T-MOBILE OFFICE BUILDING

MAJOR SITE PLAN AMENDMENT

RESPONSES - ENGINEERING SERVICE COMPANY - CARLOS BARRIENTOS

SITE PLAN
 T-MOBILE OFFICE BUILDING - MAJOR SITE PLAN AMENDMENT
 LOT 1, BLOCK 2 TOWER CENTER FOR INDUSTRY SUBDIVISION FILING NO. 2
 SITUATED IN THE NE 1/4 OF SECTION 33, T.3S., R.66W. OF THE 6TH P.M.
 CITY OF AURORA, COUNTY OF ADAMS, STATE OF COLORADO

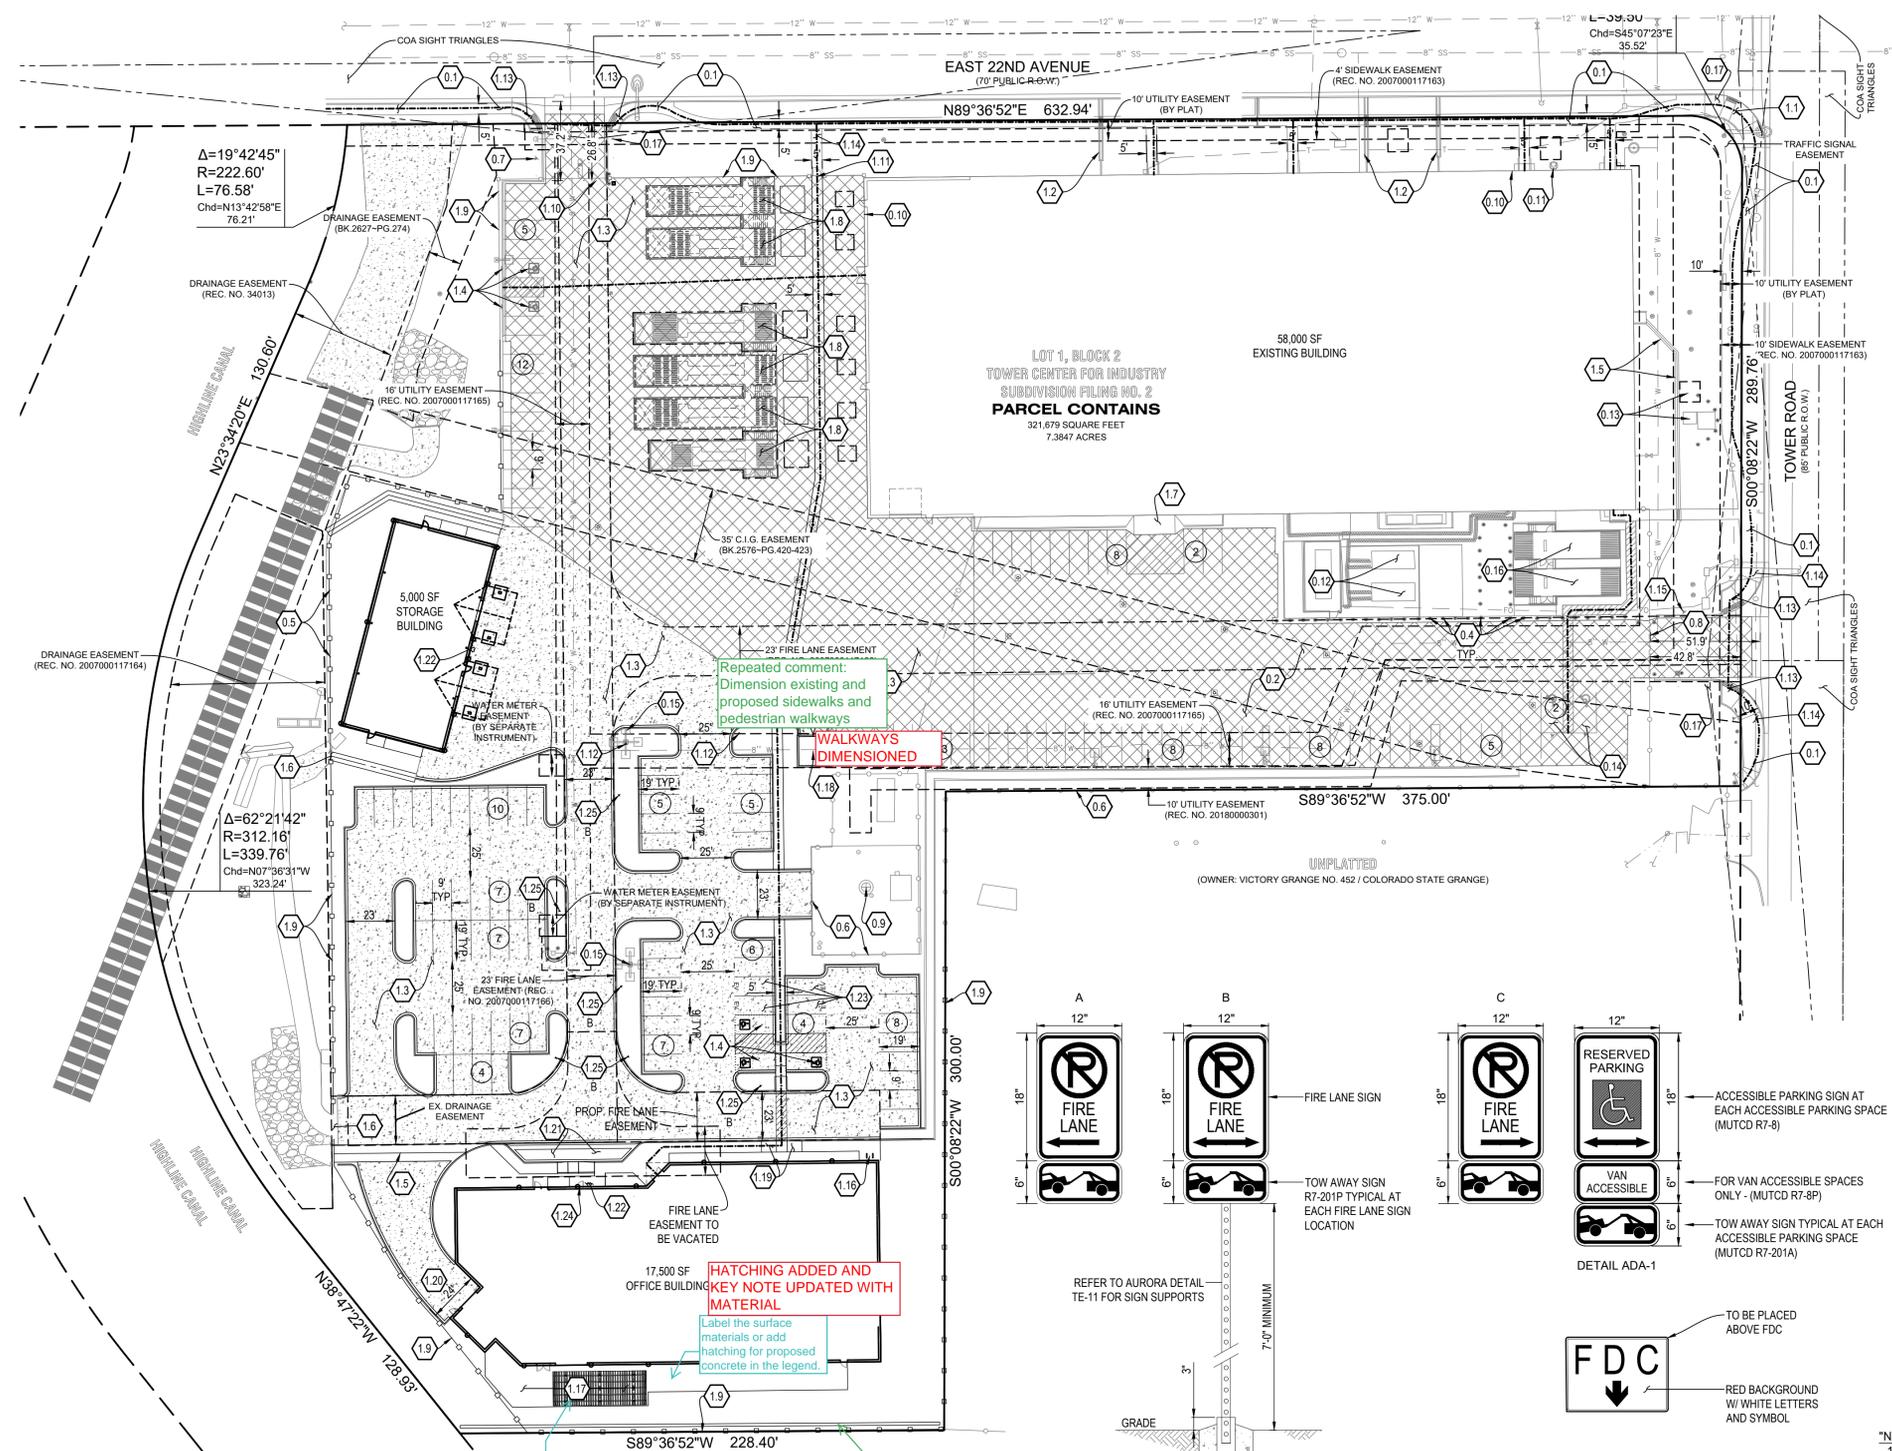
Repeated comment:
Dimension existing and proposed sidewalks and pedestrian walkways

Label the surface materials or add hatching for proposed concrete in the legend.

Label retaining wall.

Indicate masonry column spacing.

WALKWAYS DIMENSIONED

HATCHING ADDED AND KEY NOTE UPDATED WITH MATERIAL

KEYNOTE RELOCATED. KEYNOTE TO INDICATE CONCRETE PATIO AREA WITH TRELLIS

RETAINING WALL LABELED

COLUMN SPACING ADDED. MAX 72 FEET BETWEEN COLUMNS. 8 FEET BETWEEN 6"X6" WOOD POST

LANDSCAPE PLAN

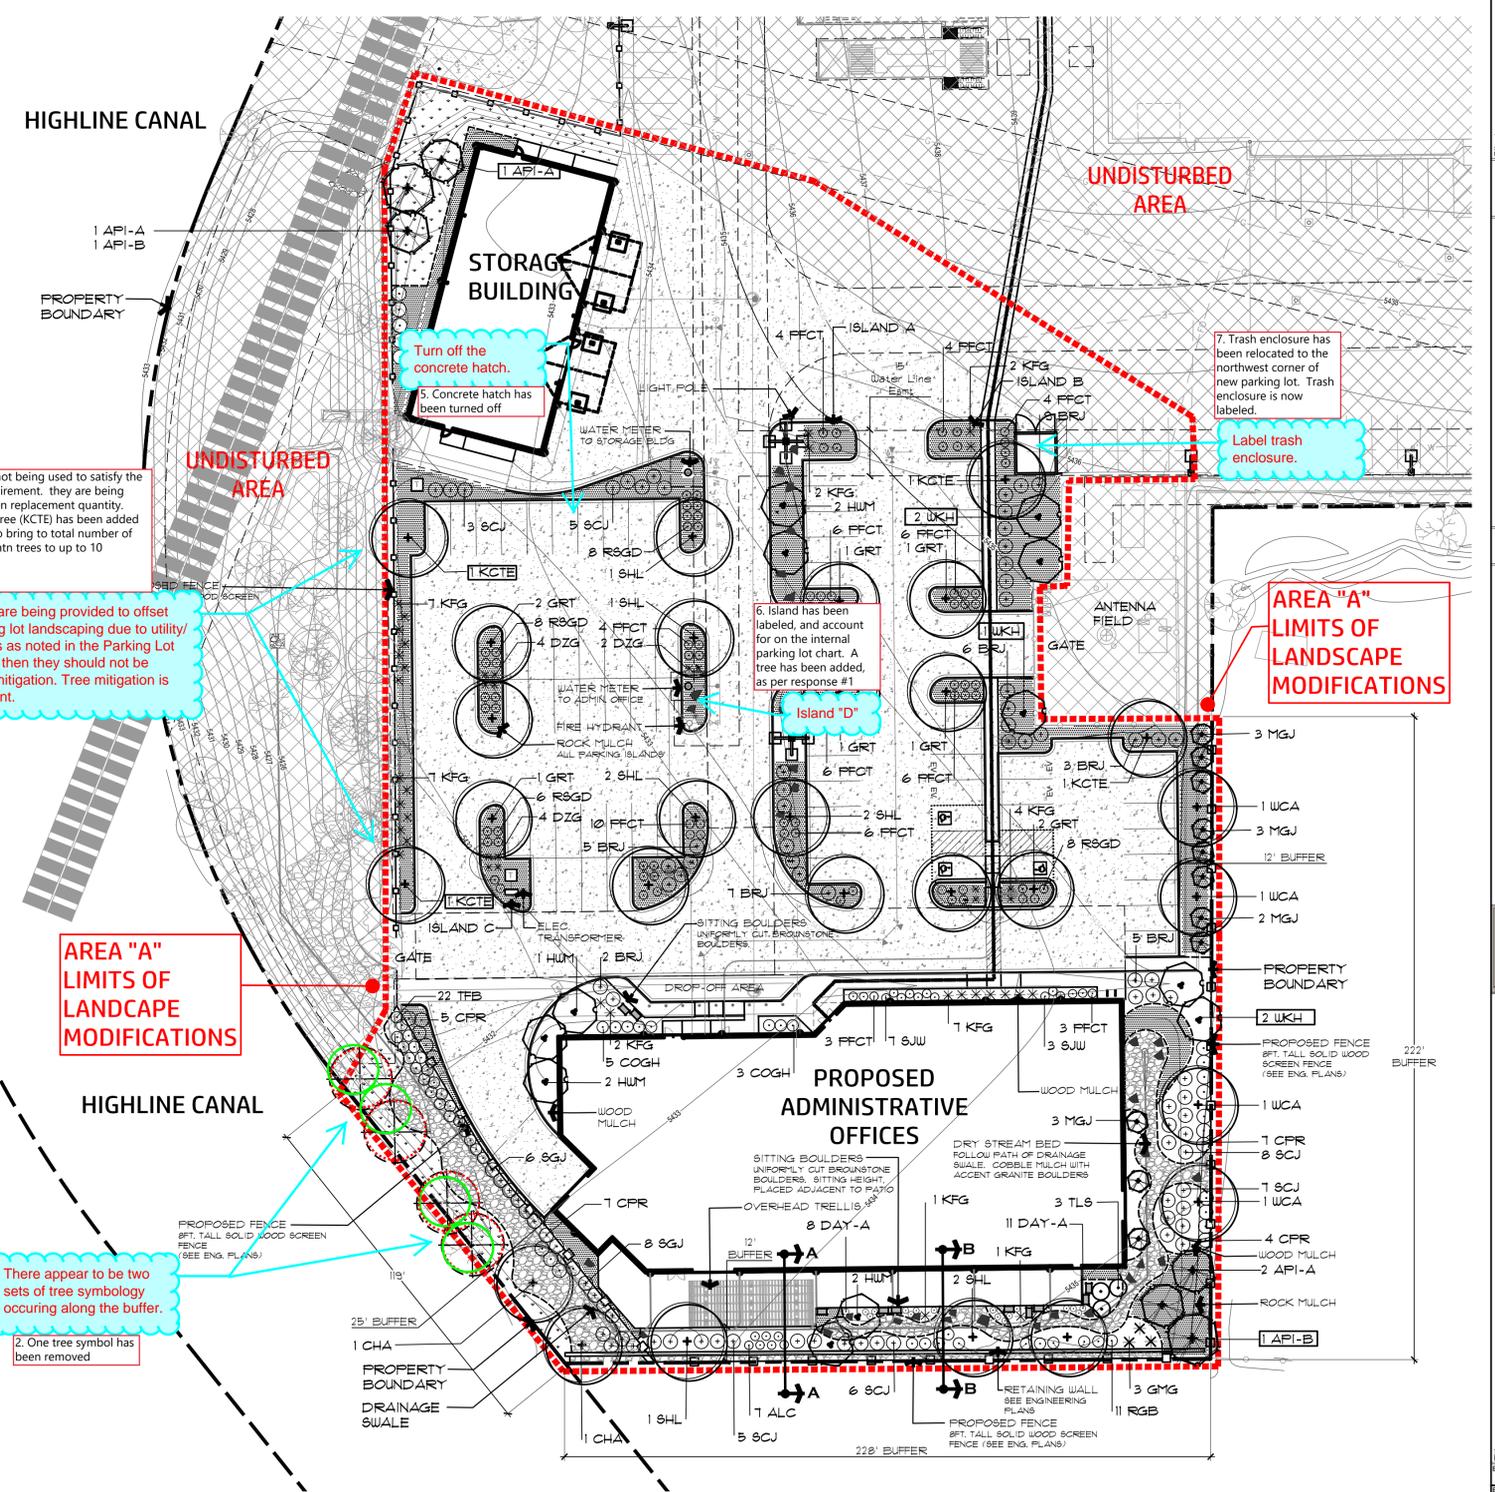
Please remove this hatch for clarity purposes. The dashed red line indicates the limit of work.

If these two trees are being provided to offset the internal parking lot landscaping due to utility easement conflicts as noted in the Parking Lot Landscape Table, then they should not be counted towards mitigation. Tree mitigation is it's own requirement.

There appear to be two sets of tree symbology occurring along the buffer.

Add "D" and another tree. See landscape plan. And add one additional tree to the perimeter of the parking lot area.

4. hatch has been removed, as requested

3. Those two trees are not being used to satisfy the internal parking lot requirement, they are being applied to tree mitigation replacement quantity. Additionally, one more tree (KCTE) has been added on the west perimeter to bring to total number of tree mitigation replacemtn trees to up to 10

2. One tree symbol has been removed

1. Island D has been labeled on the plan, and added to this chart. A tree (SHL) has been added to the north perimeter of the parking lot to bring total number of parking lot trees to 19

LANDSCAPE CROSS-SECTIONS

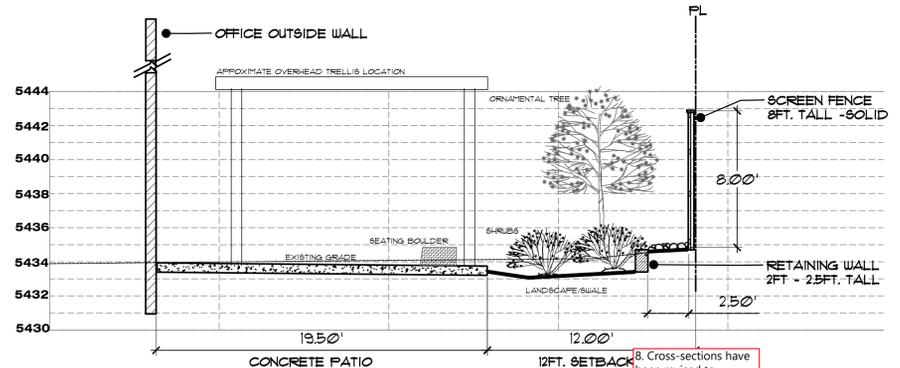
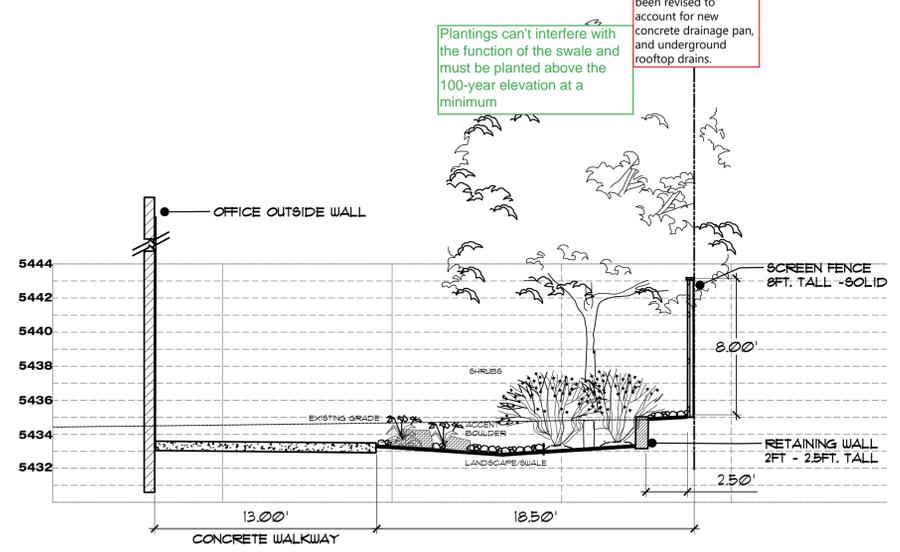
Plantings can't interfere with the function of the swale and must be planted above the 100-year elevation at a minimum

8. Cross-sections have been revised to account for new concrete drainage pan, and underground rooftop drains.
